# TECHNICAL MEMORANDUM

**To:** Coachella Valley Salt and Nutrient Management Plan Technical Group      **Date:** October 16, 2014  
**From:** MWH      **Reference:** 10505158  
**Subject:** Technical Memorandum No.1 Preliminary Data Review and Documentation of Technical Methods

## **ADDENDUM**

### **Stakeholder Comments and Response to Comments**

**Figure 5-2**

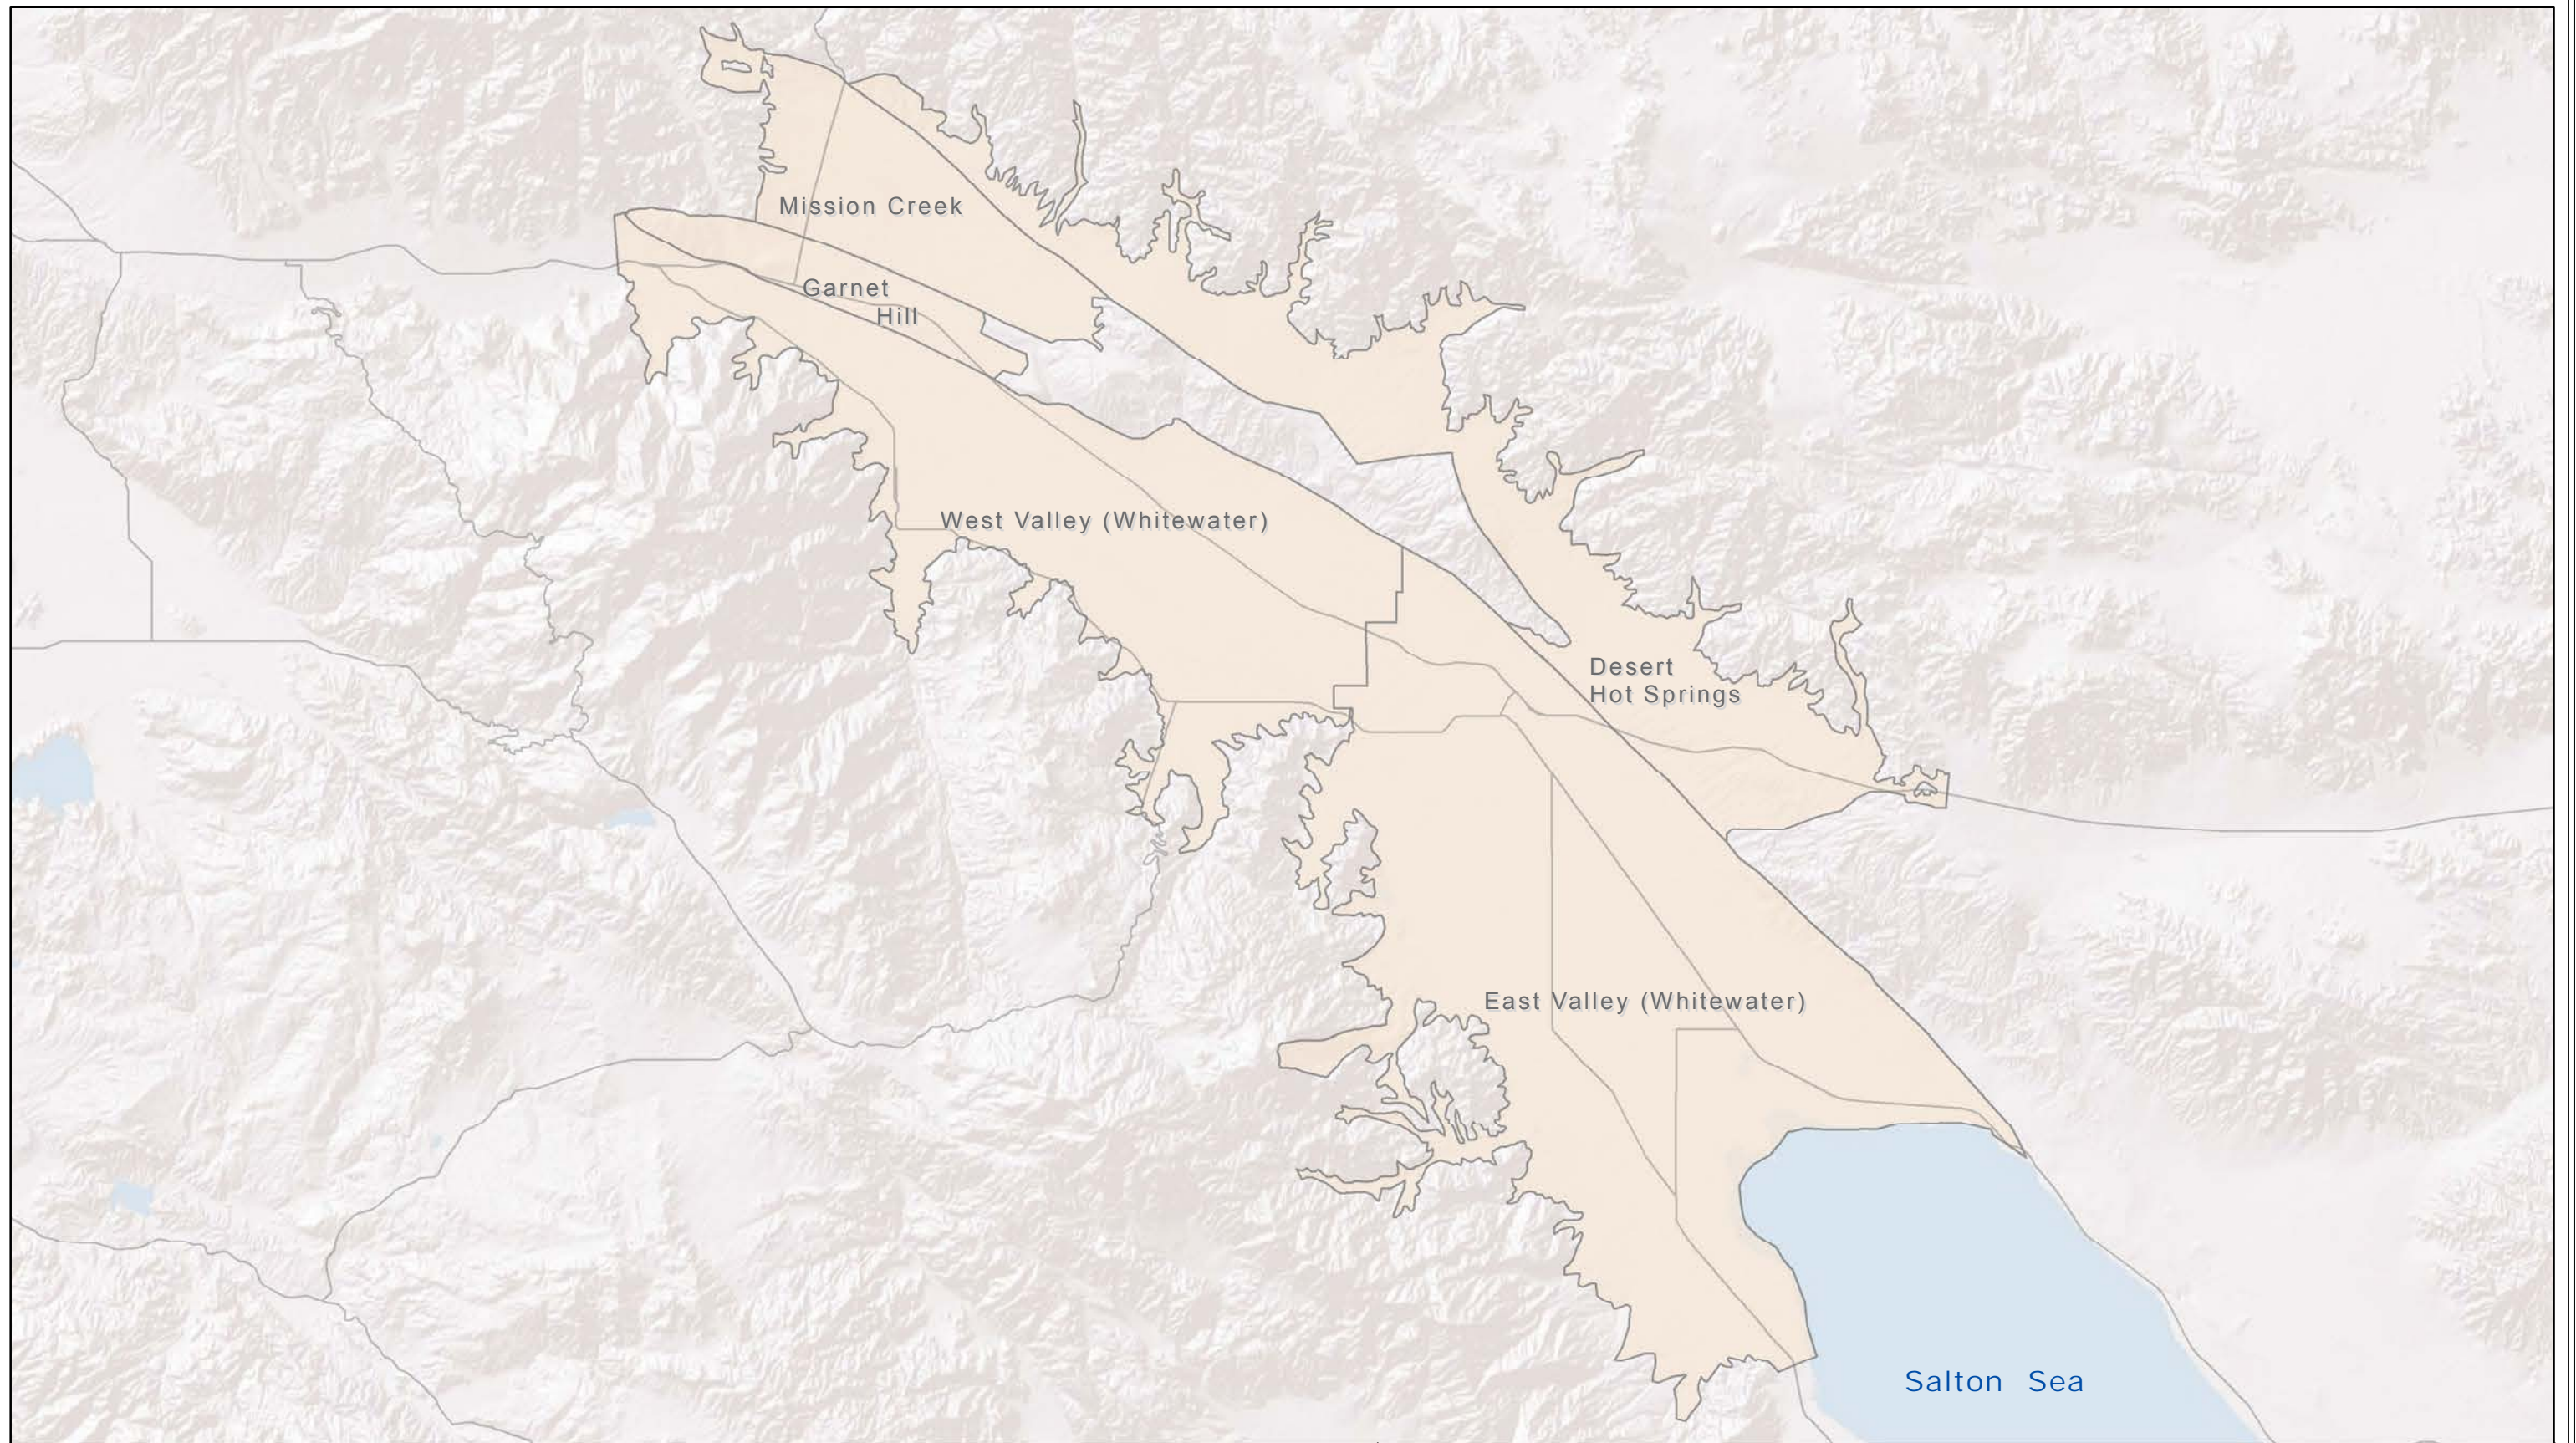
34	On page 45, Section 4.2: use of i.e. should be replaced with e.g.	Comment noted.
	35	On page 59, Figure 5-2: the legend shows a symbol for highways but none are shown in the figure.	Commented noted, the figure is modified to reflect the comment.
Bureau of Indian Affairs Robert Eben Superintendent	36	The dominant form of groundwater chemistry should be included within the anticipated baseline data. Changing groundwater chemistry, regardless of total salt load can impact the beneficial uses of groundwater. For example a change to more sodium-based waters may cause issues related to sodic soils or worst case saline-sodic soils, if groundwater sources are to be used for irrigation within agriculture or turf grass applications such as golf courses or recreational fields.	Comment noted. Evaluating the differing forms of salts is a rigorous analysis that is out of the scope for the SNMP and not feasible. TDS, however, is a commonly used surrogate for salts and other potential constituents of concern. TDS measurements are also readily available. Use of surrogates is a common practice, for example, drinking water surrogate testing for total coliform bacteria is commonly conducted as it would be infeasible to assess water sources for each individual pathogen.
